Fresenius Medical Care SERVICE BULLETIN

Equipment: 2008H
Bulletin: 00-FRH-001
Subject: Potential Hydroblock Cover Leak

Fig 1

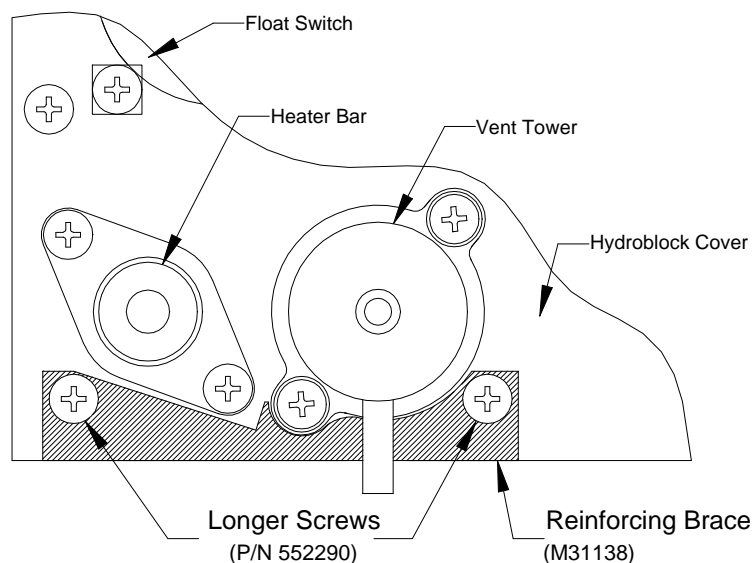
There is a potential for the hydroblock to develop a leak between the cover and body. The rear of the cover may warp between the heater bar and the vent tower. Since there is minimum water pressure at this point, the leak could be very small. Leakage in this area has no effect on the operation of the machine. If during a service call wetness or evidence of leakage is noticed in this area, install a reinforcing brace as described in this service bulletin.

Install the reinforcing brace (M31138) to the top of the hydroblock cover using longer screws (552290). Refer to figure 1 for correct placement.

Note: Do not overtighten the longer screws when installing the reinforcing brace. Only tighten them enough to remove the warp in the hydroblock cover.
